Peach Bottom Atomic Power Station, Unit 2
Facility Operating License No. DPR-44
NRC Docket No. 50-277

Subject: Supplement to the Request for License Amendment Related to
Main Steam Tunnel Temperature - High, dated February 12, 2004

Supplement to License Amendment Request for
"Main Steam Tunnel Temperature - High"

Response to Request for Additional Information

Figure 1 - HVAC Modeling Scheme

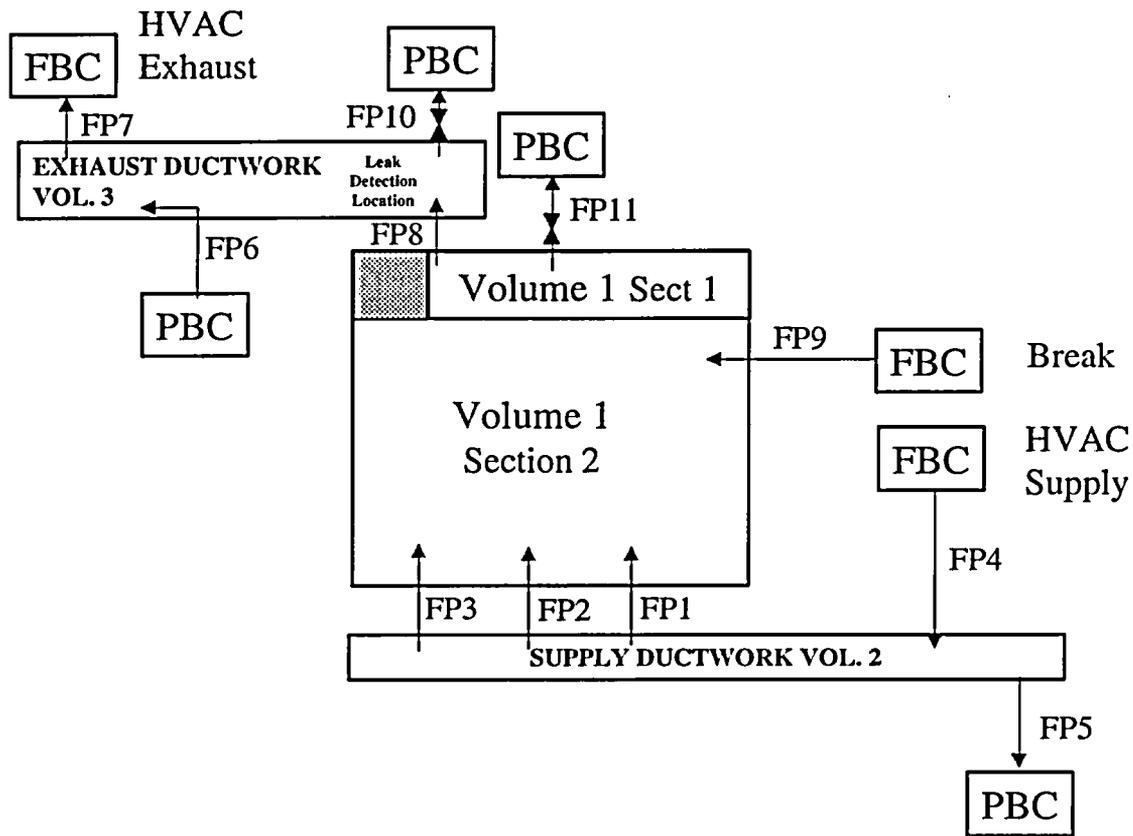
- (1) Provide a description of the GOTHIC nodal model (include the GOTHIC version number) used to model the buildings (volumes, flow paths, active heat removal systems and heat structures, and their initial conditions). Identify the model used for the break flow, the model(s) used for heat transfer to structures, and the model(s) used for flow between volumes.

The Main Steam Tunnel was modeled as a single subdivided volume. The volume is subdivided based on the location of the piping systems as well as the general structure of the room (Refer to Figures 2 through 4). The exhaust and supply ductwork are also modeled as subdivided volumes (Refer to Figures 5 and 6). The ductwork volumes are treated as having only a single elevation. Figure 1 illustrates how each of these volumes is connected within the model.

As illustrated in Figure 1, the MST is supplied with ventilation air from volumes and flow boundary conditions representing the normal and SGTS ventilation flows. The ventilation ductwork volumes are also connected to neighboring areas within the reactor building. The passive contribution of the neighboring areas on the ventilation flow is modeled using junctions and pressure boundary conditions. The flow path junctions to these neighboring plant areas are provided to account for their influence on both the normal and SGTS ventilation, as well as escaping steam in the event of a steam leak. The inclusion of this feature allows steam to leave the room via the supply as well as exhaust ductwork. This is important to ensure the model does not over predict the steam leaving via the exhaust ductwork where the detectors are located, thereby biasing the model into an earlier detection of the leak.

As illustrated in Figure 1, the normal ventilation flow into the Main Steam Tunnel is provided by three flow paths. Three flow paths are provided to symmetrically provide flow to the room relative to the steam line locations, which is consistent with the actual plant configuration.

The approach used in modeling the ventilation flow was to assign a constant volumetric flow rate using a Flow Boundary Condition for the ventilation supply and exhaust. Under steam leak conditions, it is possible that steam enters into the supply ductwork preventing flow into the room. To accommodate this approach it is necessary to include the ductwork volume and the associated boundary conditions as illustrated in Figure 1. These features apply to both the loss of HVAC and steam leak evaluations.

The pressure relief function of the two blowout panels is modeled in the analysis of the main steam leak response. These blowout panels are associated with flow paths FP10 and FP11 shown in Figure 1. These flow paths include critical flow modeling using the tables option provided in GOTHIC. The inclusion of the blowout panels ensures that their influence on the response of the detectors is modeled. Since these panels are located upstream of the detectors they have the potential to divert steam flow from the detectors, and the inclusion of them in the model is appropriate.

The break flow into the MST is modeled for the steam leak assessments using a flow boundary condition and flow path FP9 illustrated in Figure 1. The two break sizes are assumed to be 1% and 10% of total steam flow. The break flow rates are based on the rated full power main steam flow rate documented in the UFSAR. Therefore, the 1% break flow assumes 1% rated steam flow and the 10% break flow assumes 10% rated steam flow. A Critical Flow calculation is not performed for determining break flow using the GOTHIC computer code. The flow boundary condition requires enthalpy and pressure in addition to the flow. These two parameters are set in the model to correspond with nominal process conditions. The flow area for each break size is calculated to correspond with the appropriate critical flux of the system.

FIGURE 7

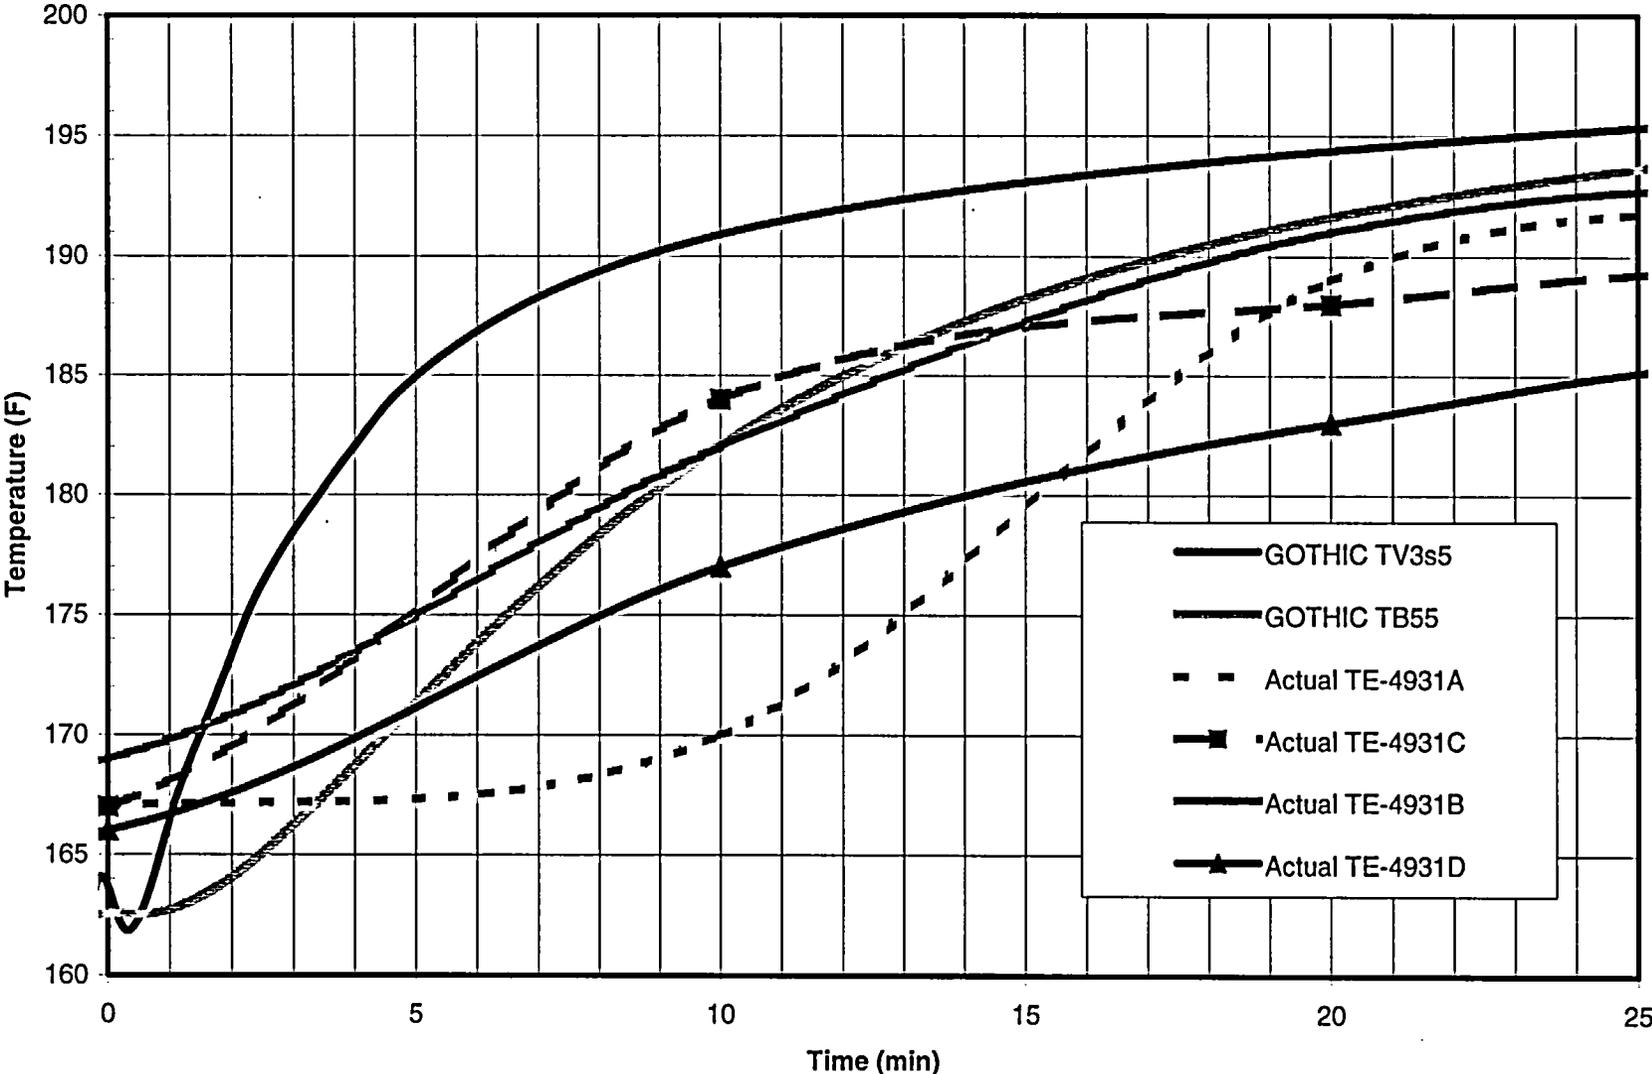
- 3) Provide the results of the benchmarks against the loss of ventilation events, and the results for the LAR calculation(s).

The results of the loss of HVAC benchmark evaluations are provided in Figures 7 and 8. These figures compare the detection instrumentation (TE4931A/B/C/D) with the GOTHIC model vapor temperature in the area of the detector (TV3s5) as well as the GOTHIC model detector temperature (TE TB55). The results of this comparison show that the model provides a reasonable comparison with the events.

Figures 7 and 8 demonstrate that the GOTHIC model results bound the maximum temperature response during a loss of HVAC. This ensures the selected setpoint does not result in a spurious isolation during a loss of HVAC.
